Docket Number:	19-ERDD-01
Project Title:	Research Idea Exchange
TN #:	232050
Document Title:	CalWave Power Technologies Inc. Comments - Comments 1-3 OSW3, Resource and Cost Metrics
Description:	N/A
Filer:	System
Organization:	CalWave Power Technologies Inc.
Submitter Role:	Public
Submission Date:	2/14/2020 6:53:53 PM
Docketed Date:	2/18/2020

Comments 1-3 OSW3, Resource and Cost Metrics

Comments on Staff Webinar- EPIC Research Roadmap on Utility-Scale Renewable Energy

Fig. 4. Co-located array of 26 WECs staggered in two rows, and 80 turbines in an oblique rectangle layout. Fig. 5. Cable layout for co-located array: inter-array cabling is in thin line, with export cable in thick line (export cable continues to shore).

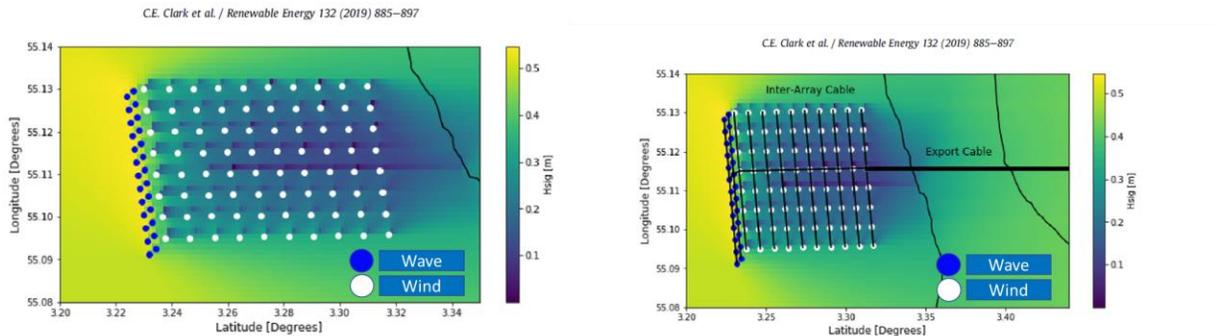
Comment summary: Suggest to solely focus on co-locating wind and wave farms instead of combining technologies using the same permits, export cables, installation and maintenance vessels but leaving distinct clearance between both farms (see Fig. 4. & 5. Cable layout for co-located array, <https://doi.org/10.1016/j.renene.2018.08.043>).

Suggest to solely focus on collocating wind and wave farms instead of combining technologies using the same permits, export cables, installation and maintenance vessels but leaving distinct clearance between both farms to achieve:

1. Increase combined capacity factors and respective system level cost of storage
2. Reduction in CAPEX by utilizing shared project cost and infrastructure
3. Reduction in OPEX by utilizing shared vessel and vessel trips

Figure 4-1
Example Graphical Comparison for Buoy 46054 Wave Power Density

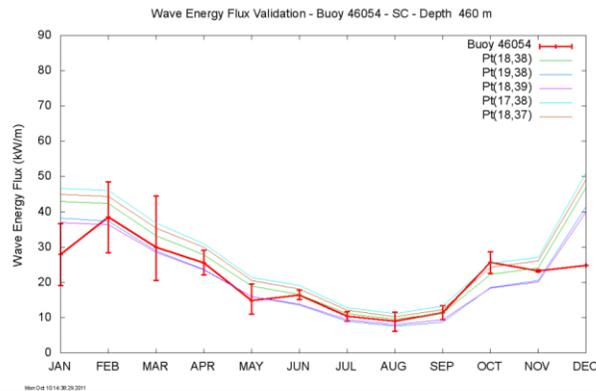
Suggestion to further the E3 & Castle wind study by also adding 7-9 GW of wave to the mix and quantify the respective savings in storage.

Wave power shows a promising and complementary output profile next to solar and wind that can produce power at night and during winters.

Figure 1: Daily average and hourly output of CalWave wave energy convert at central California case study site for Southern California Edison, Vandenberg. Source: CalWave internal analysis based on NBDC wave data.

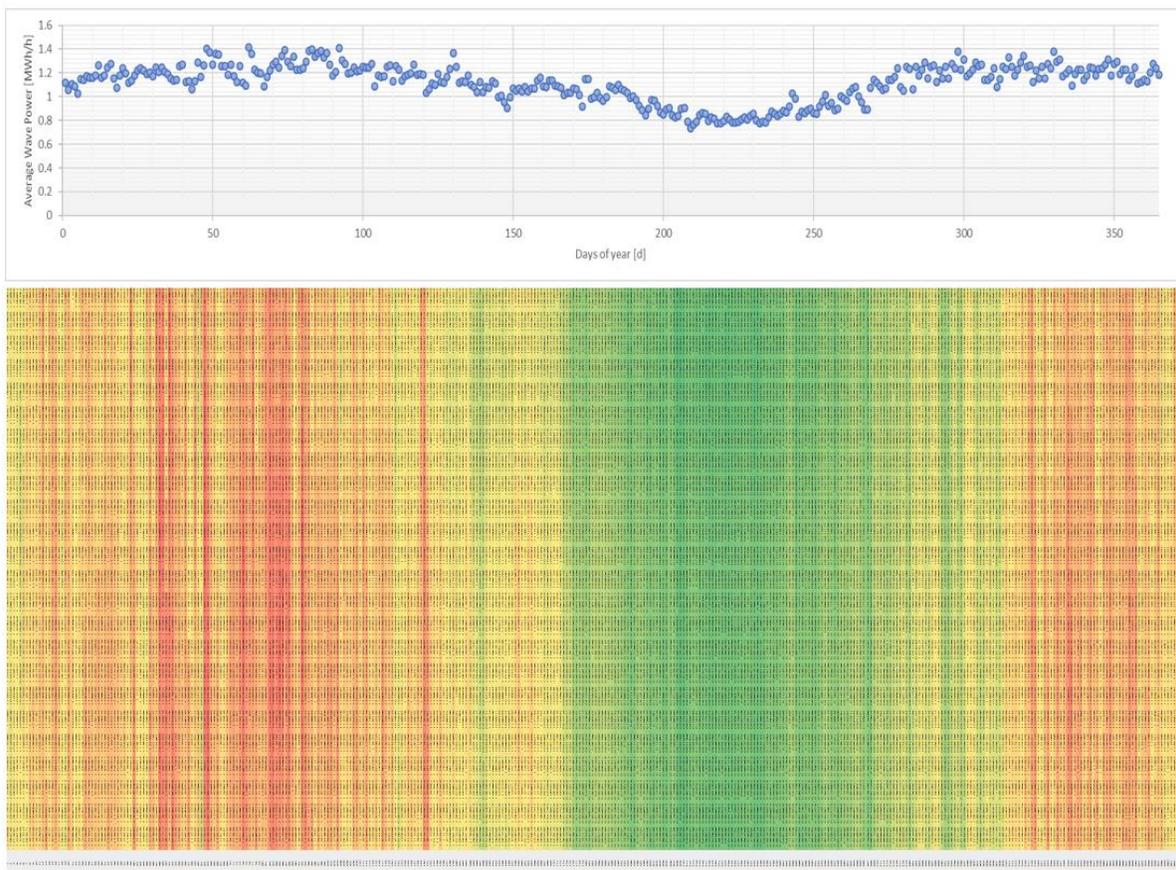
Exemplary wave farm output profile for California projects stable annual and daily production profile.
